Product Support Bulletin 2010-018

DATE:	June 9, 2010	
SUBJECT:	Potentially Sticky Propel Valve – 500743	
RATING:	X DIRECTIVE (Action is required)	ALERT (Potential Problem)
MACHINE	INFORMATION (Action is optional)	PRODUCT IMPROVEMENT (Enhance Product)
MACHINE MODEL(S):	AA2R – Dual Rail Anchor Adjuster NSCA – Spring Clip Applicator SP2R – Dual Rail Spike Puller	
SERIAL NUMBER(S):	AA2R – Dual Rail Anchor Adjuster: 650001-650013 NSCA – Spring Clip Applicator: 290026-290031 SP2R – Dual Rail Spike Puller: 310162-310175	
SUMMARY:	The Propel Valves on these machines with date codes of A09S through C10S may stick due to a slightly undersize valve bore.	
OPERATIONAL IMPACT:	If the Propel Valve sticks, the machine may continue to move after the operator releases the Propel Foot Pedal. The machine will stop if either Brake Pedal or the Emergency Stop Pushbutton is depressed.	
ACTION:	Check the Propel Valve date code. The date code is located on the valve name plate and consists of a letter followed by 2 numbers and then the letter "S". The first letter indicates the month of manufacture and the 2 numbers indicate the year. The letter "S" indicates the place of manufacture. If the Propel Valve

Figure 1

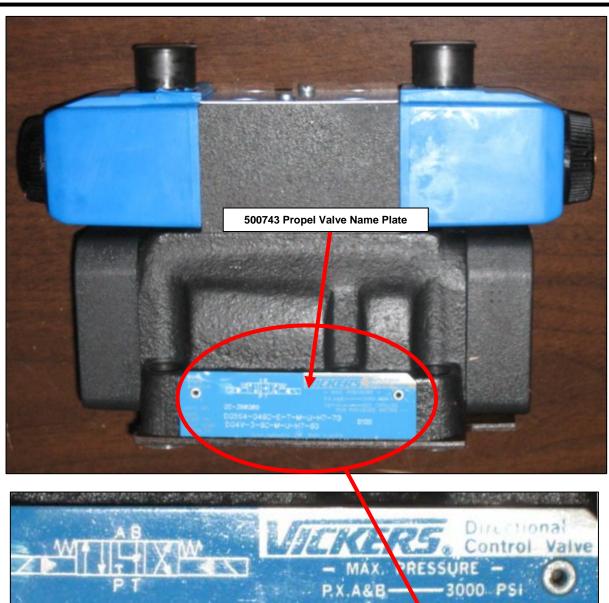
500743 Propel Valve date code location on the valve nameplate This example is D10SS (April, 2010) indicating this is a good valve

WARRANTY:	Any valves with the date codes listed above installed on a machine with a serial number listed in this bulletin will be replaced under warranty by Nordco. To order a replacement valve, contact the Nordco Service Department at 1-800-445-9258. You must have the machine serial number available and the defective valve must be returned to Nordco after
